Certified Action Of the City of Raleigh Planning Commission

Case File / Name: S-27-13 / The 10 at South Person

Staff Report

S-27-13 / Subdivision Layout

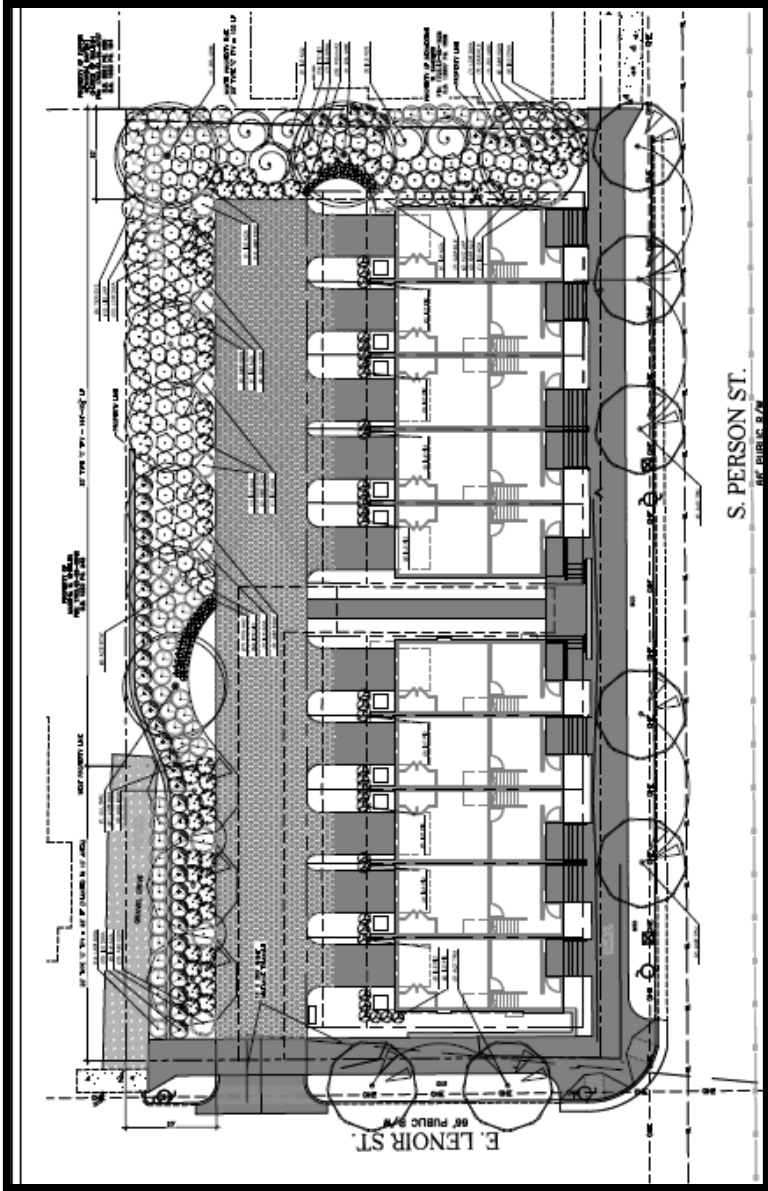
Code Section 10-2082.9 – Requires a 20' Type C transitional protective yard along the western property line. The request is to provide a 13' width yard along 65' of the western property. The remainder of the western property line would meet the 20' width requirement. Shrubs will be planted at 24" at installation (18" required by code section 10-2082.6(b)(5)). Trees will be installed at 12' in height (8' required by Code Section 10-2082.6(c)(2)).

Code Section 10-2103 subsections (b)(2) and (h) - Not providing 30' separation between buildings that are greater than 28' in height with windows on the affected side. Code Section 10-2103(h) allows the Planning Commission to approve a different building to building separation. The request is to provide a 13' 2" distance between the buildings on Lot 5 and Lot 6. Additional shrubs will be planted adjacent to the buildings installed at a height of 24".

Code Section 10-2051 (d) (5) - Not providing 14' sidewalks on East Lenoir Street, South Person Street; applicant is requesting an open space alternate. The request is to provide an 8' sidewalk with a 6' tree lawn along East Lenoir Street and South Person Street. This request was approved by the Historic Development Commission.

- (1) That the Planning Commission approve an Alternate Means of Compliance to Code Section 10-2082.9 – reducing the required 20' Type C transitional protective yard to 13' (65' linear length) along the western transitional protective yard. The Commission in accordance with Code Section 10-2082.4 (a) finds that the alternate transitional protective yard is equivalent as that prescribed by Code Section 10-2082.9;

- (2) That the Planning Commission approve an alternate design to Code Section 10-2103(b) (2) dwelling to dwelling separation of 13' 2". The Commission in accordance with Code Section 10-203 (h). finds that the alternate provides equivalent privacy ;

- (3) That the Planning Commission approve an alternate design to Code Section 10-2051(d)(5) sidewalk construction of 8' with a 6' tree lawn. The Commission in accordance with Code Section 10-2051(d) (5) finds that the sidewalk pavement width reduction is in accordance with the general plan for the physical development of the City as embodied in the Raleigh Comprehensive Plan;
